**CITY OF DOVER BOARD OF ADJUSTMENT
AGENDA**

Applicant #V-17-16

545 North DuPont Highway. TLM Realty has requested a variance from the requirements of the *Zoning Ordinance*, Article 5 §4.7 pertaining to permitted signs. Specifically, the applicant seeks to permit two additional (2) wall signs over the maximum two (2) wall signs allowed for a building with a single street frontage. The site is located on the east side of North DuPont Highway north of Townsend Boulevard. It is 0.86 acres +/- in size and is currently occupied by a Panera Bread Restaurant. Subject property is zoned C-4 (Highway Commercial Zone) and subject to the SWPOZ (Source Water Protection Overlay Zone). Tax Parcel: ED-05-068.09-01-34.01-000. The owner of record is Dover DE Retail, LLC and the applicant is TLM Realty Corp.

V-17-16

Exhibit E1

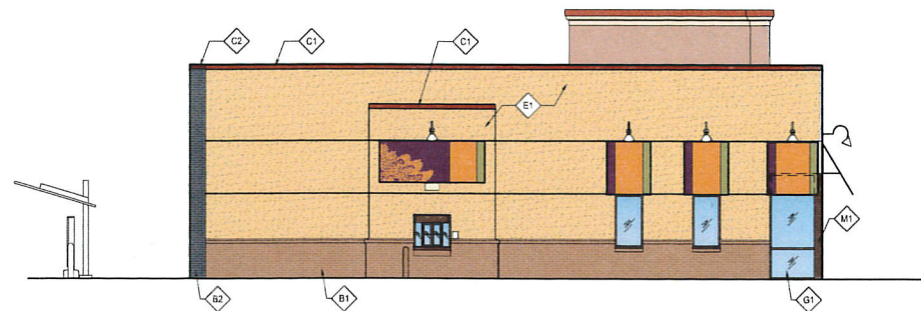
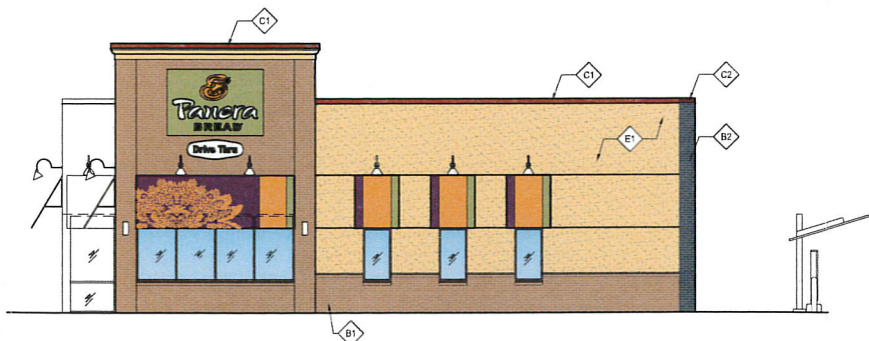
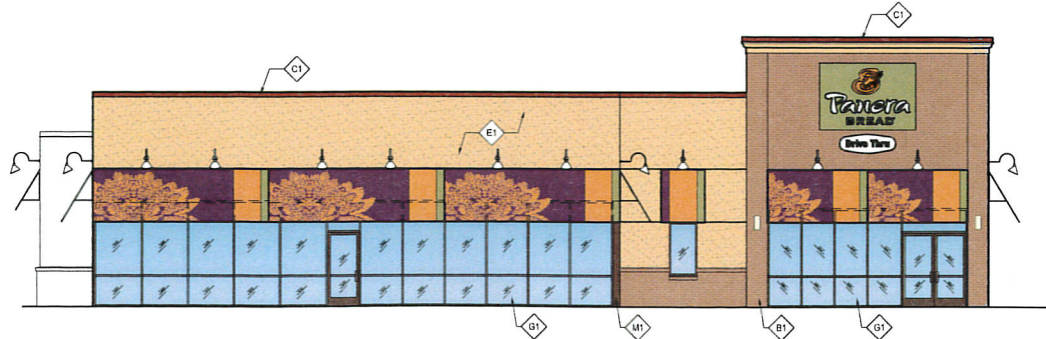
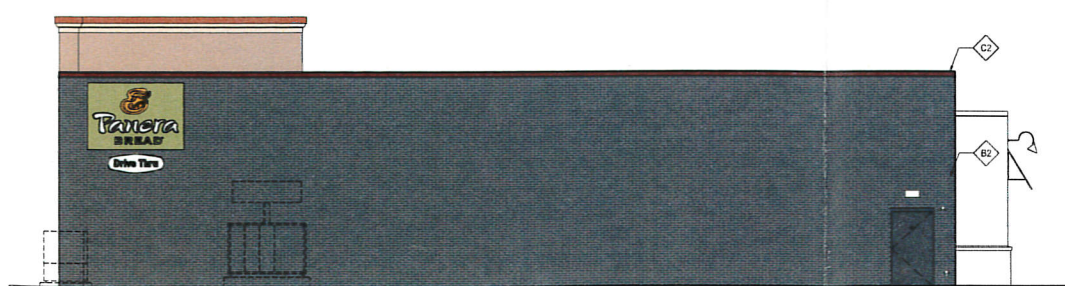
2. For the second, larger sign (Sign 4 in Table 1), the applicant's argument hinges on the sign being an integral part of the architecture of the building. The architecture of the building went through four iterations during the Site Plan and Building review processes, and at various points Planning Staff did have concerns that the north façade, on which this sign is painted, would present as a blank wall without some additional architectural detailing. Blank walls are in conflict with the City's building and architectural design guidelines as outlined in *Zoning Ordinance* Article 5 Section 19.

The initial architectural submission, dated October 6, 2016 and shown in Exhibit E1, showed a north wall that was almost entirely blank. A revised submission, dated November 11, 2016 and shown in Exhibit E2, was the version shown to the Planning Commission for Conditional Approval. This version included a row of windows on the wall which improved the architecture of the north façade. A second revised submission, dated December 22, 2016 and shown in Exhibit E3, was presented to the Planning Commission on January 17, 2017 as a revision to the original plan. This version moved the drive thru to the north side of the building, again altering the north wall's appearance; a large sign replaced the windows as the main feature of the façade. The final version of the architecture is that actually built, shown in the photographs in Exhibit F, as well as in Exhibit D along with the proposed signs. This version features both windows and the proposed large sign as features of the wall.
